## II. LRR-25

**Change Parts : 20 MHz Crystal**

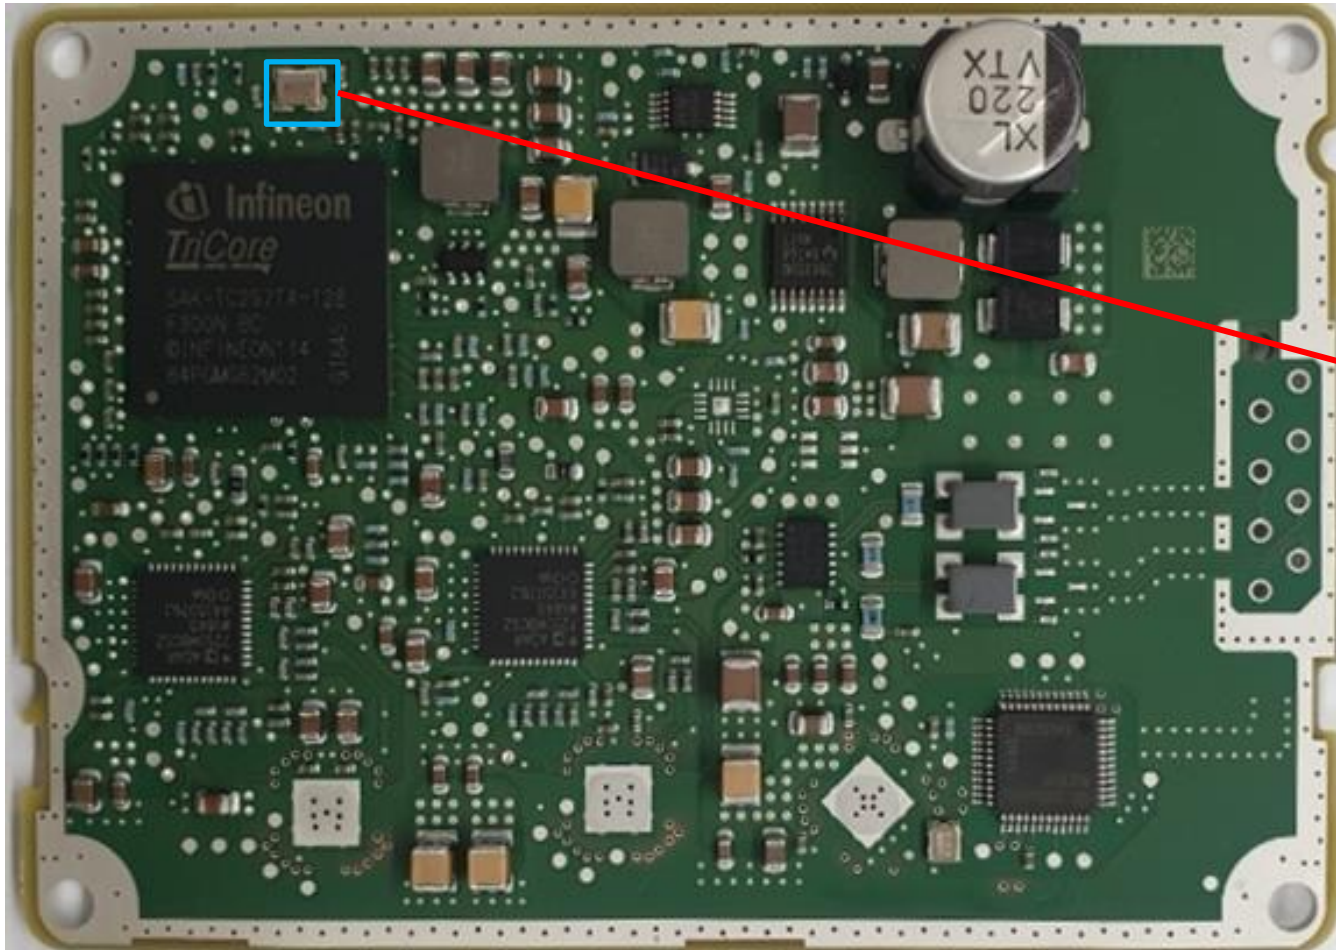
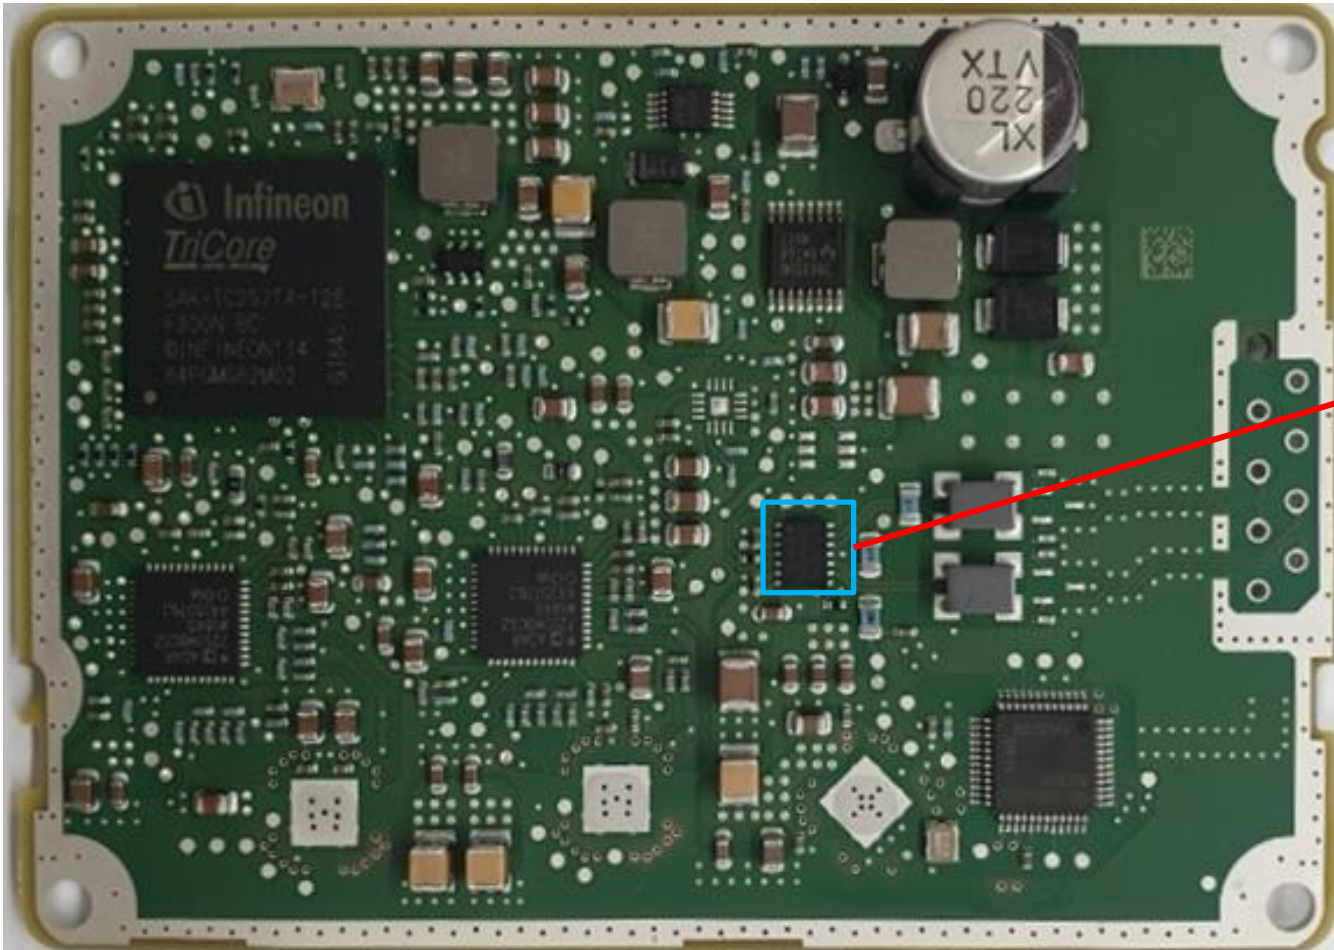
**Kyocera CX3225SA20000D0PTWZ1**

**NDK NX3225GA STD-CRA-1**

- 1) Pin to Pin Changed
- 2) No S/W Changed
